# Design Review Update

## Parcel I - Residential

Reference: Parcel I (Residential) Design Review Update  
PB #179  
Cambridge Crossing  
Cambridge, Massachusetts

Reference: Parcel I (Residential) Design Review – View Glass  
PB #179  
Cambridge Crossing  
Cambridge, Massachusetts

CAMBRIDGE CROSSING - PARCEL I  
SITE PLAN (LEVEL 03 SHOWN)

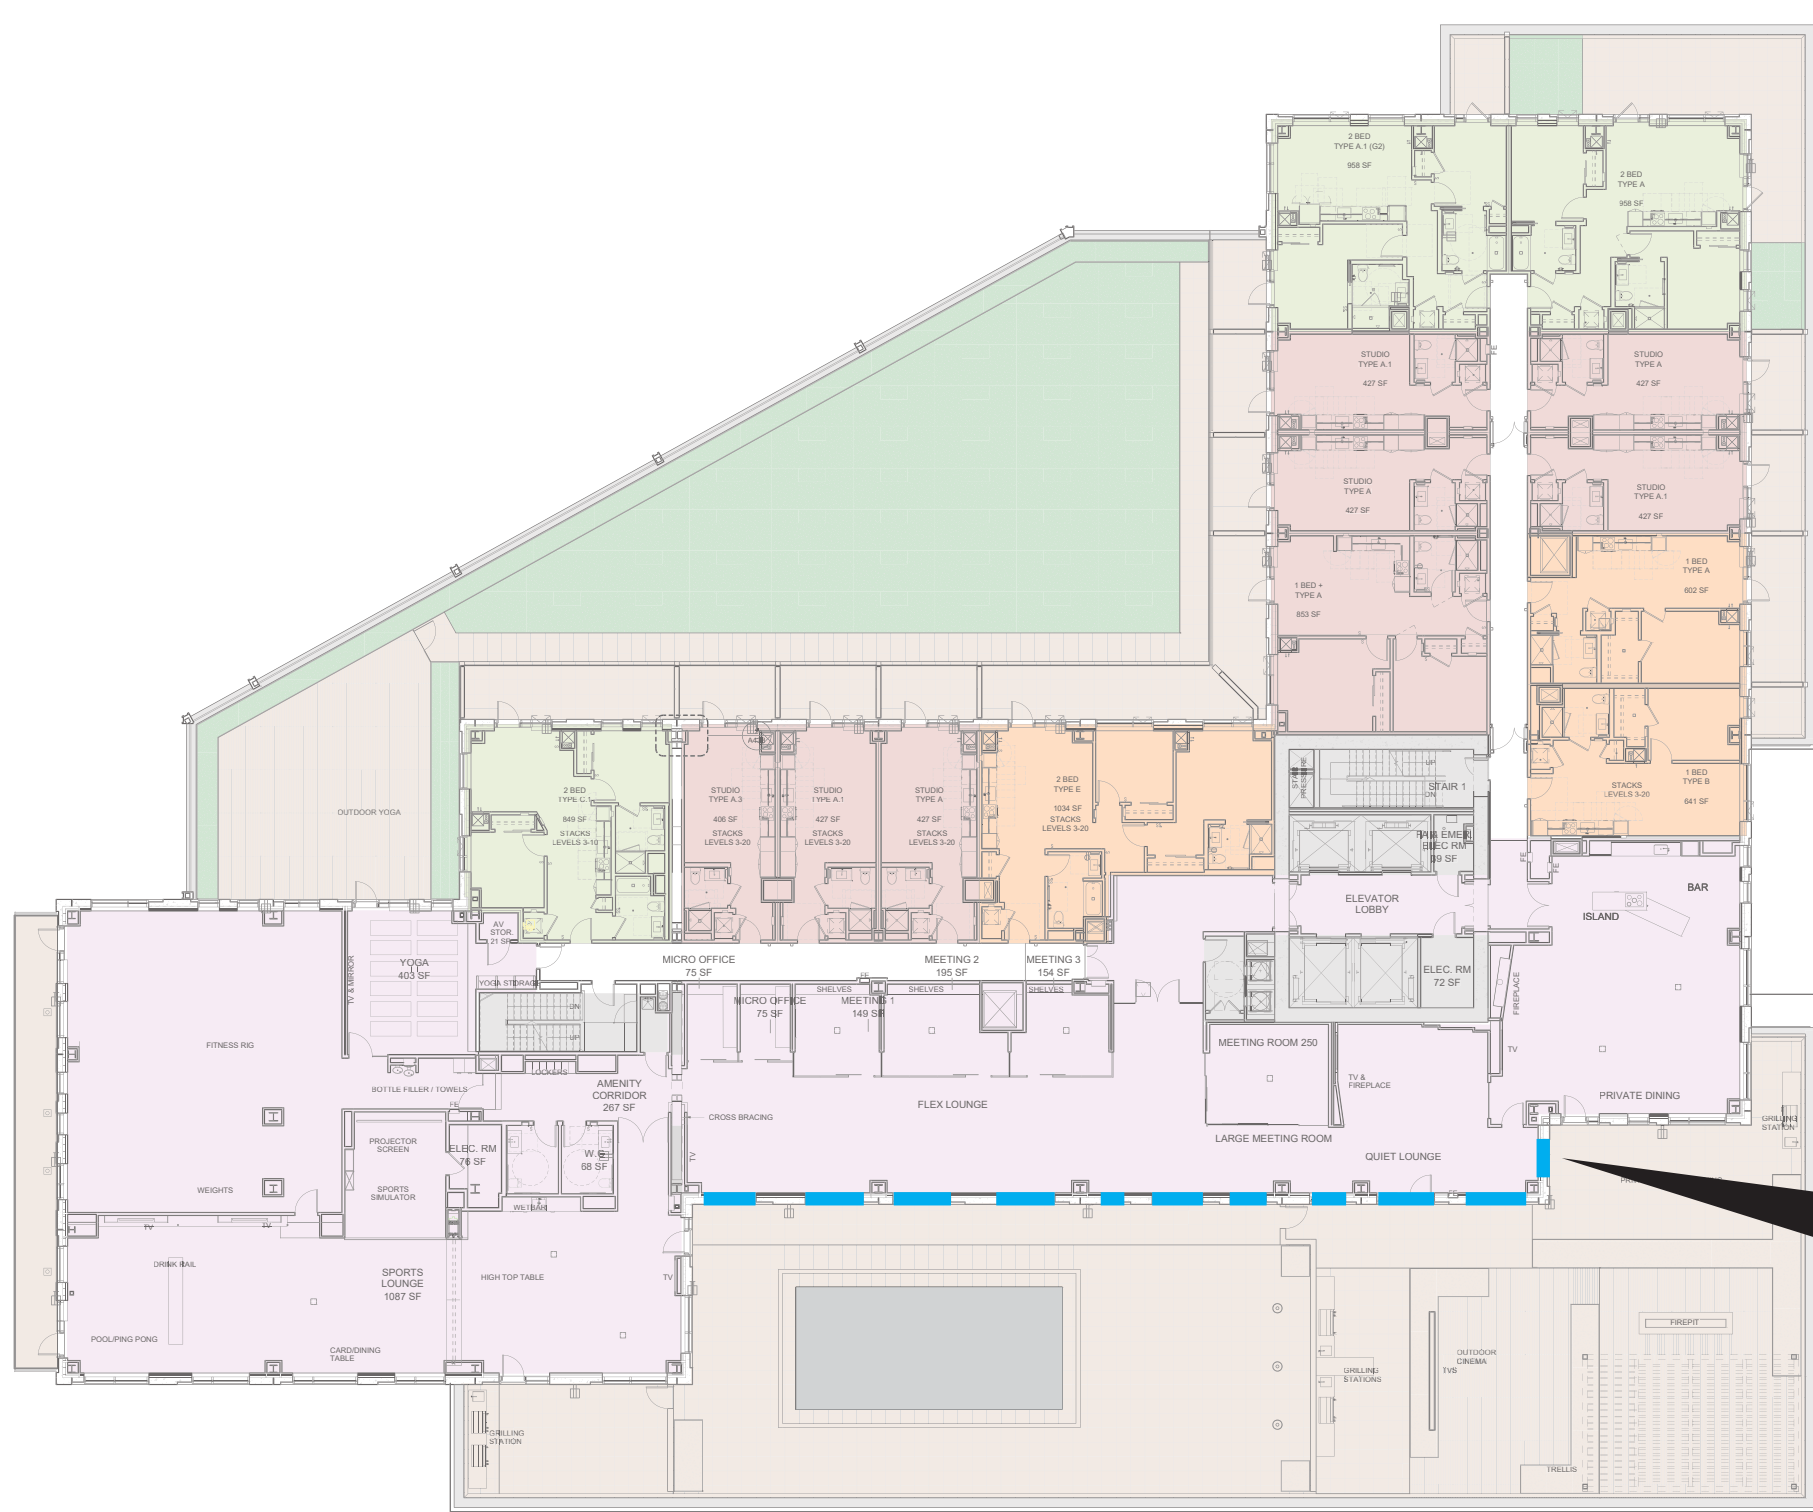
Scope of windows at Level 03 Amenity with ViewGlass

Indicates extent of public realm in which ViewGlass is visible. Images in this presentation on pages 4,5, and 6 have trees removed for clarity.
